5.1 NO. 80 (LOT: 102; D/P: 413590) AUCKLAND STREET, NORTH PERTH - PROPOSED SINGLE HOUSE

RECOMMENDATION:

The proposal was referred on three occasions to the City’s DRP Chairperson for comment as considered against the 10 principles of good design. The DRP Chairperson’s summarised comments, the applicant’s responses to these and subsequent amendments made to the plans are included in **Attachment 6**.

Site Plan - Landscaping

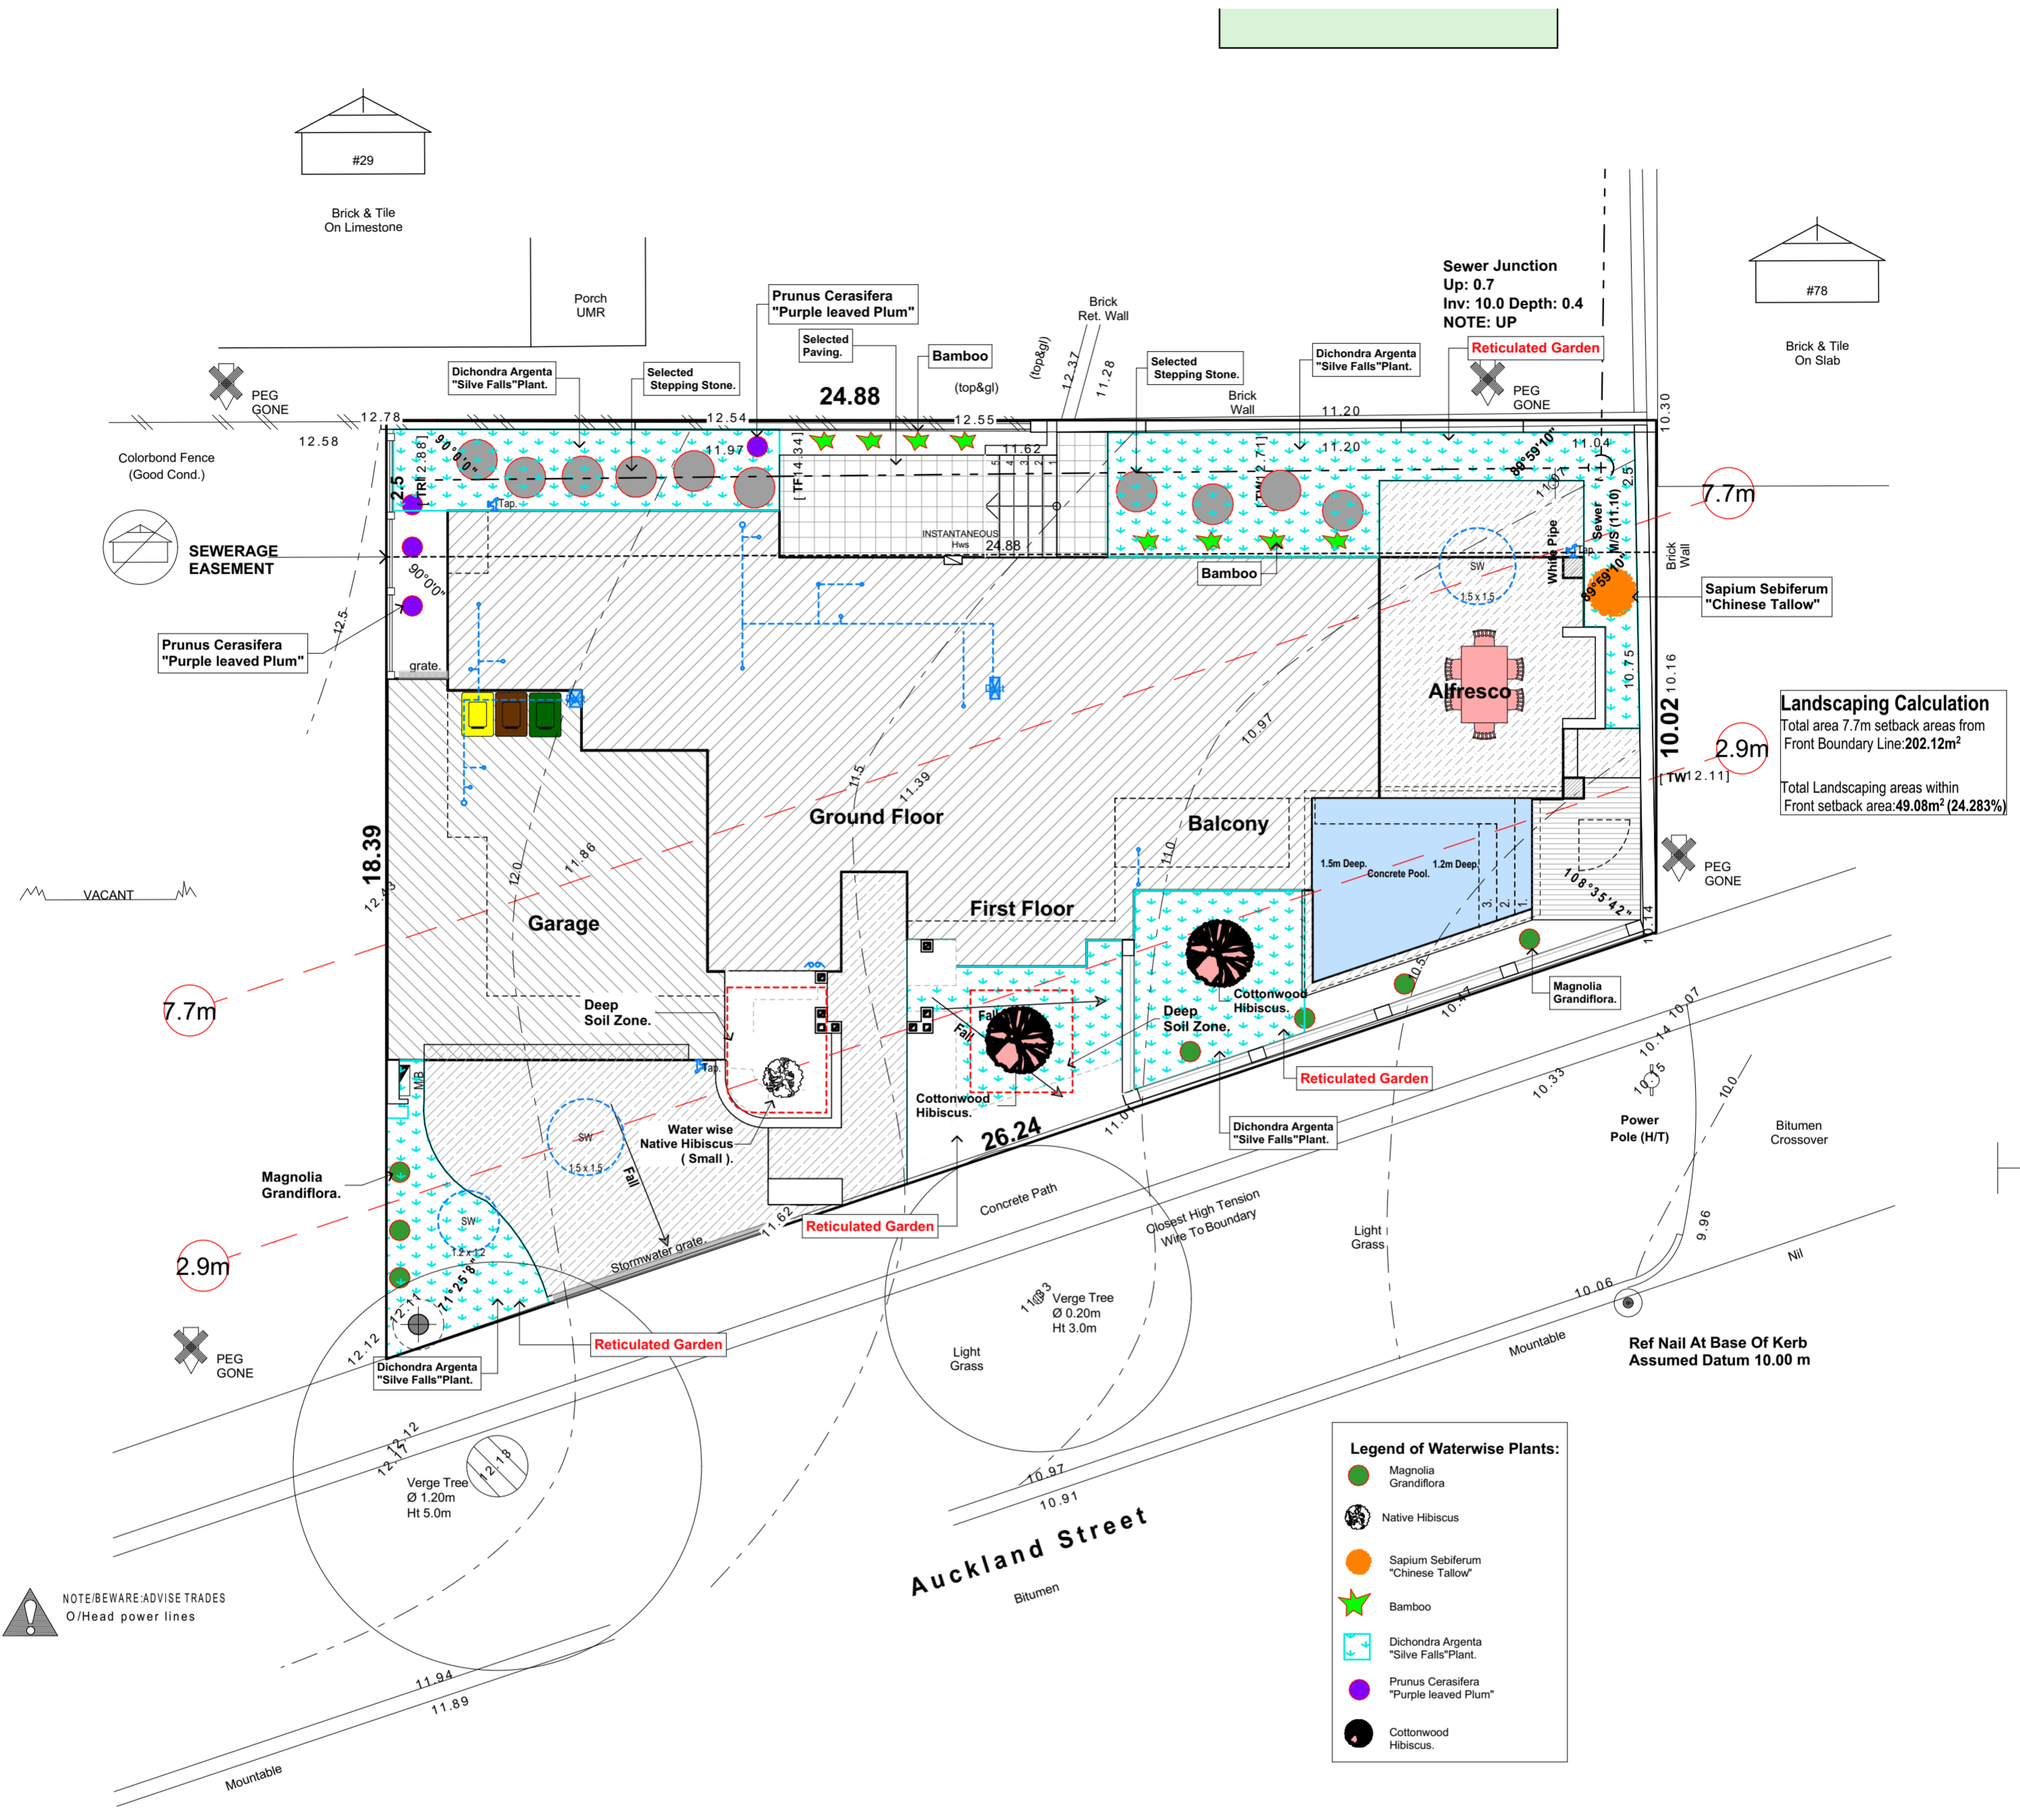
- The City's Parks team supports the tree species proposed. Further consideration is required to confirm the appropriate spacing between the trees to be planted to ensure it maximises canopy coverage and is viable. It is recommended that an updated landscaping plan be provided as a condition of approval to confirm tree planting and groundcover specifications, details and spacing.

8.1 An updated detailed landscape and reticulation plan for the development site and adjoining road verge, to the satisfaction of the City, shall be lodged with and approved by the City prior to lodgement of a Building Permit. The plan shall be drawn to a scale of 1:100 and show the following:
